Re: California Public Records Act Request

DEPARTMENT OF TRANSPORTATION (CALTRANS)
ENCROACHMENT PERMIT
DM-10-1-102A (REV. 2/82)

and subject to the following, PERMISSION IS HEREBY GRANTED to: Construct a deceleration lane in the southbound lane and revise the driveway to the northbound lane of State Highway 101 at post mile 9.66 in San Luis Obispo County as shown on the attached plans.

Subject: Plan Review and/or Encroachment Permit Review

OVERALL SITE PLAN

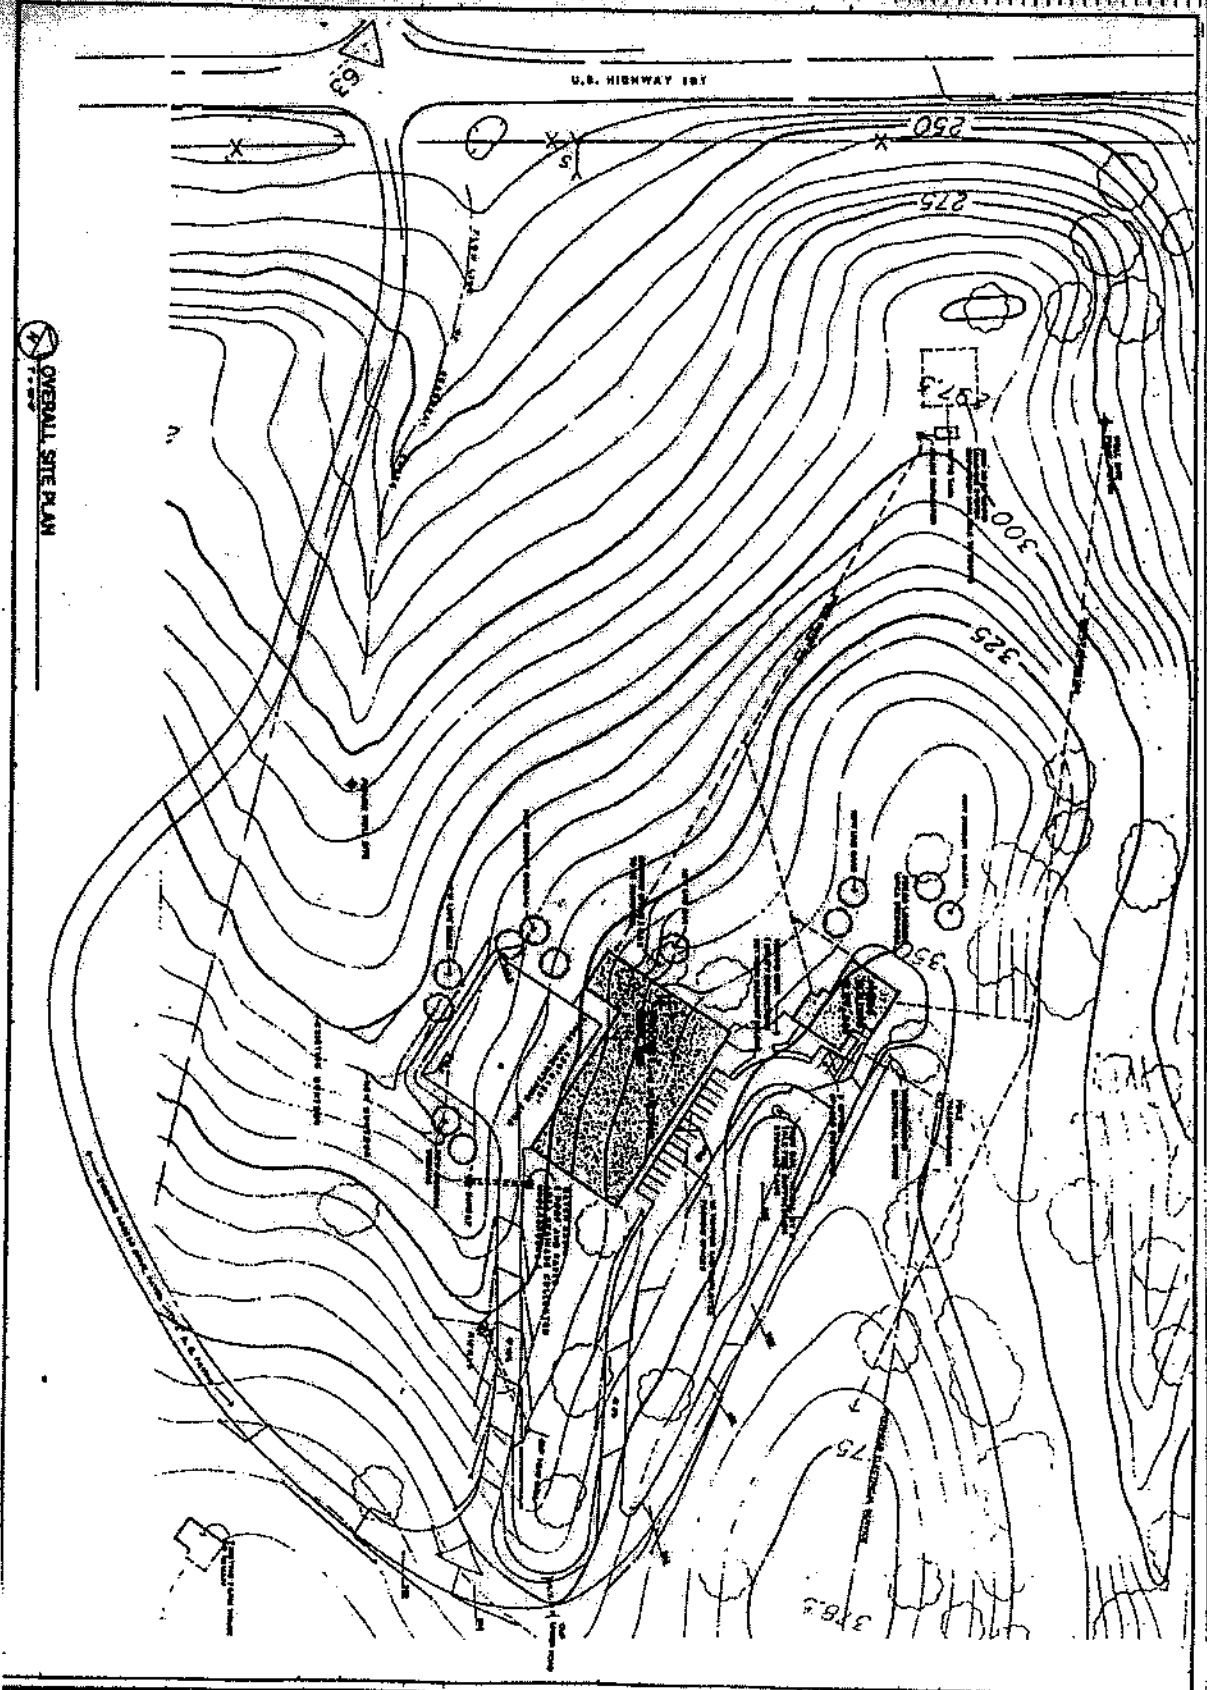
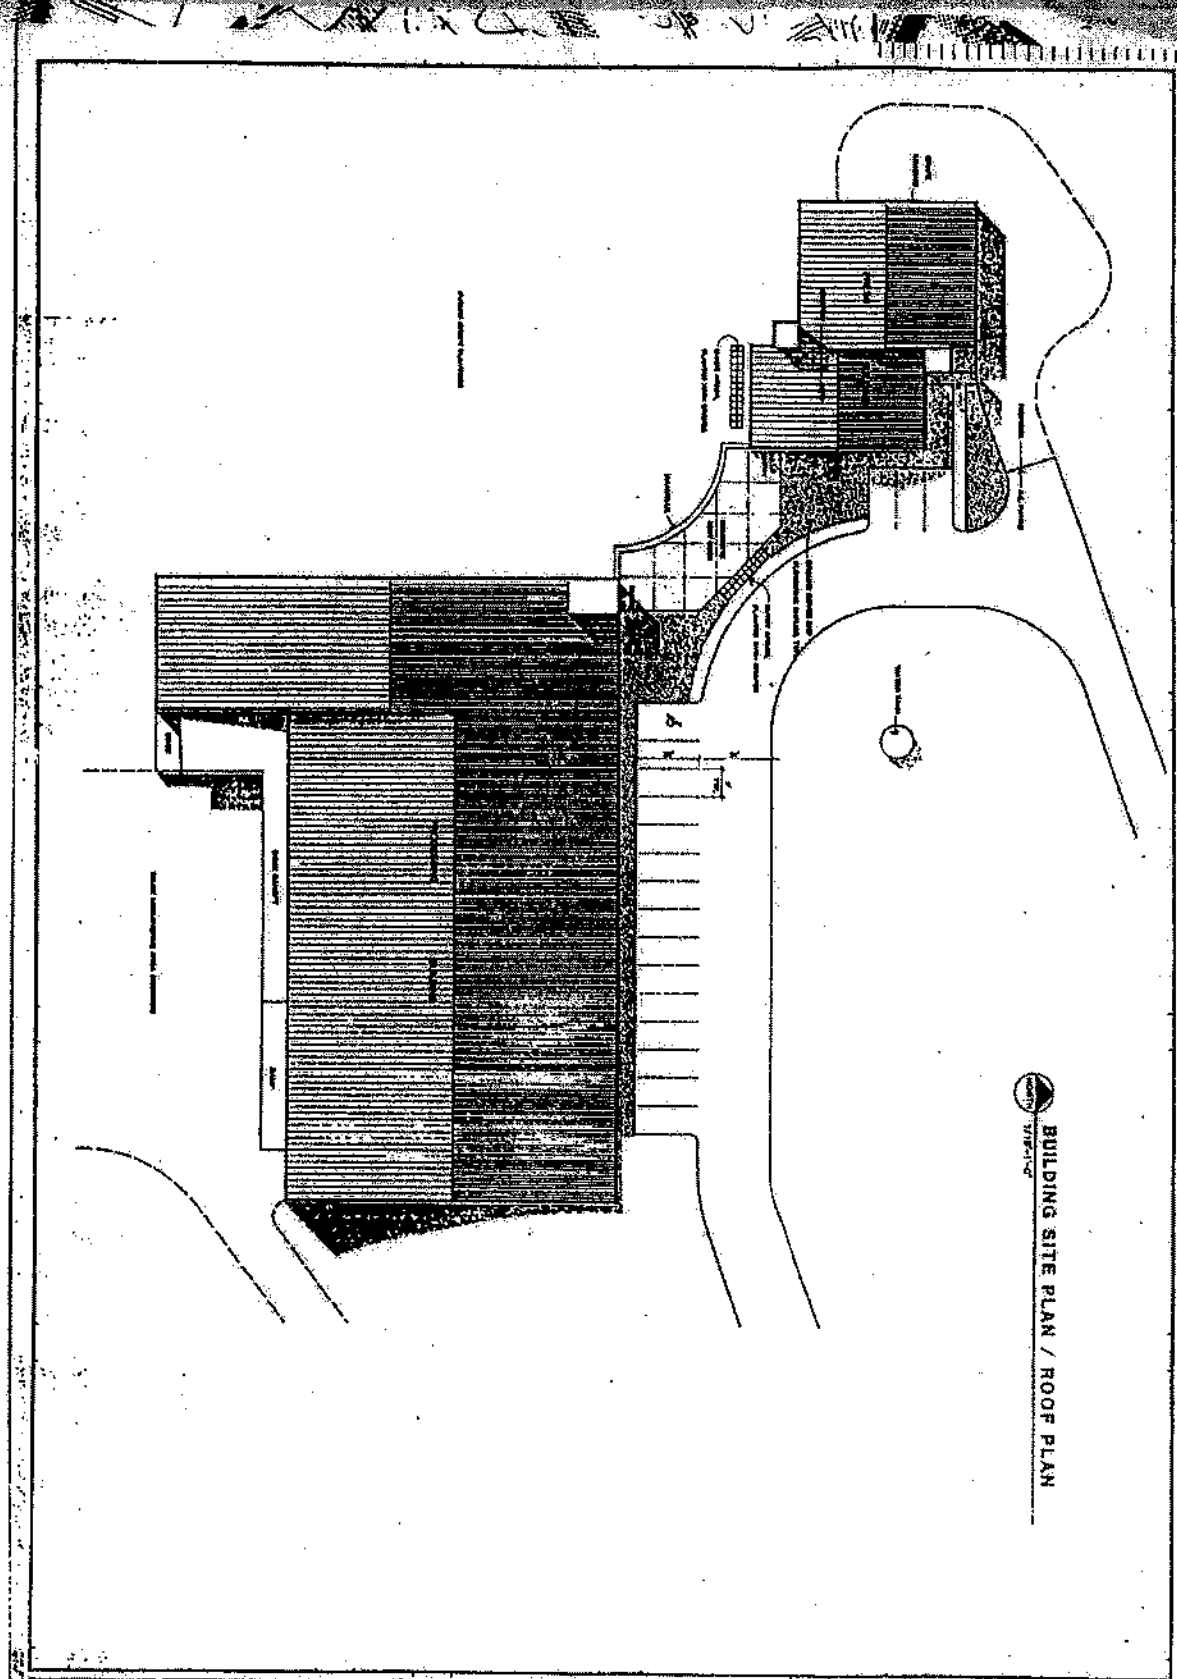
We have reviewed the plans for the Pressoir-Deutz Winery near Los Berros Road and Highway 101 in San Luis Obispo County. Our review generated the following comments:

1. The road connection should conform to the "Minimum Design for Road Connections" Type II. (See attachment.)
2. Please omit the northbound acceleration and deceleration lanes and the southbound acceleration lane.
3. The southbound deceleration lane should be a minimum of 300 feet long, in addition to the transition flare. The lane width should be 12 feet with a 5-foot shoulder.
4. All utilities, including underground utilities, that are in the vicinity of the proposed project should be shown on the plan.
5. The striping should be done by the State striping crews. The developer must then reimburse the State for the cost.

Told him he has only 20' opening & should
make rd approach 20' wide @ R/W. Also
should show R/W on plan and needed 3' backup
for shoulder on decal lane instead of 2' &
should show location of dike on road approach.
He will submit permit application with these changes
